Access Compliance Report

Public Rights-of-Way

(Pedestrian Signals)

Intersection ID: N/A	Main Street:	Cross Street: N/A	Location: N/A
ADA ID: F839CB3B2CB7	Signal Type: One Push Button-APS	Overall Compliance: No	Severity Score: BTN 1: N/A BTN 2: N/A No BTN: N/A
Codes/Mitigation Info/Possible Solution		Field Measurements/Component Compliance

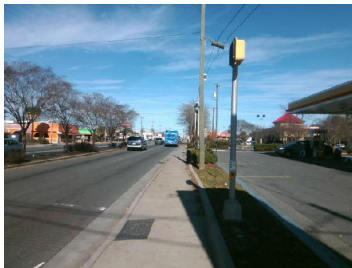
PROW/ADA: TMUTCD 4e.08, R404.3, R404.1, R404.7.3, R209.1, MUTCD 4e.10

Yes	B 1 Clear Xing Direction?	ClearlyMarked	N/A	B 2 Clear Xing Direction?	N/A
	B 1 Crossing Direction	To W		B 2 Crossing Direction	N/A
Yes	B 1 DistanceTo XWalk (in)	0.0	N/A	B 2 DistanceTo XWalk (in)	N/A
No	B 1 DistanceTo Curb (in)	96.0	N/A	B 2 DistanceTo Curb (in)	N/A
Yes	B 1 Diameter (in)	2.0	N/A	B 2 Diameter (in)	N/A

Possible Solutions: Replace Signal Push Button With APS Button on New Post. Remove & Relocate Sign.
